# STS-126/ULF2

## FD 05 Execute Package

MSG 034A - FD05 FLIGHT PLAN REVISION

Figure 1 - Orbiter Lower Surface

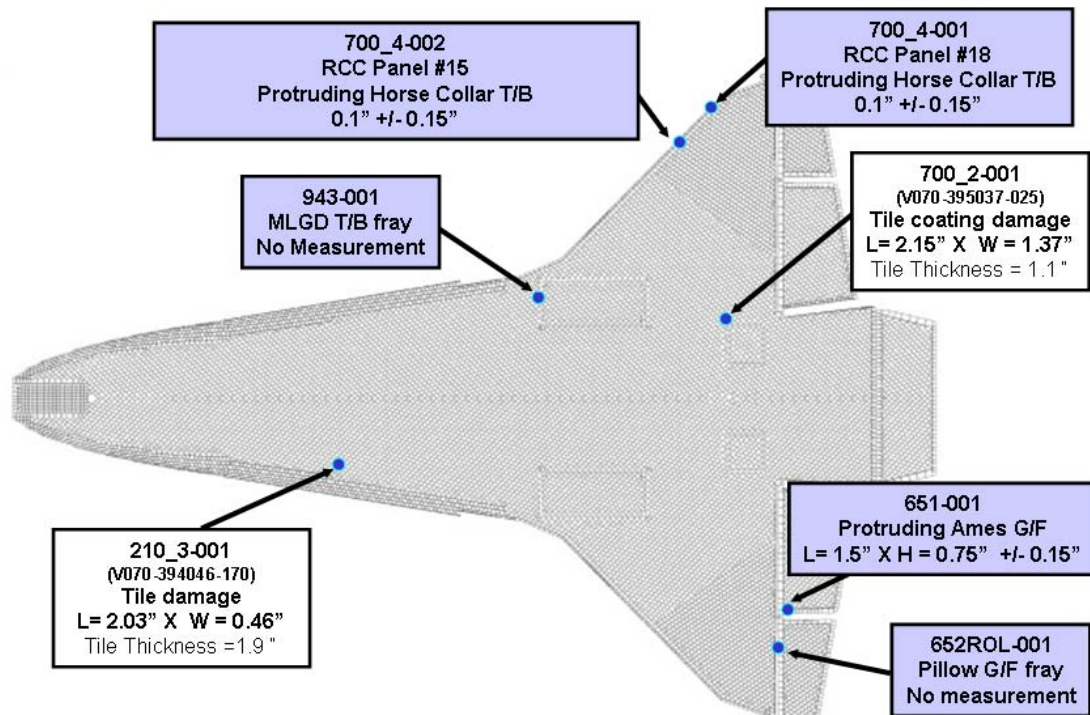
11  
12 **Damage Assessment Team** - Analysis of the ascent imagery, FD02 inspection data and  
13 the RPM photos is nearly complete. For the RCC, the team has cleared all of the Regions  
14 of Interest; therefore, the RCC is considered clear for entry. For the rest of the TPS, there  
15 are 13 Regions of Interest identified. 5 of these ROIs are damage to tile, but none of the  
16 observed damage is significant and all is within our experience base. The team is still  
17 performing their rigorous analysis of these areas and expects to be complete with the  
18 damaged tile assessments by tomorrow's MMT. The other 8 ROIs are due to thermal  
19 barriers and gap fillers. 7 of these have already been cleared, but the 15" gap filler  
20 protrusion on the ROMS pod requires additional work. The team is not concerned about this  
21 gap filler, but wants to fully assess this longer than previously observed OMS pod gap filler.

22 Also, no Focused Inspection will be required for any of these ROIs.
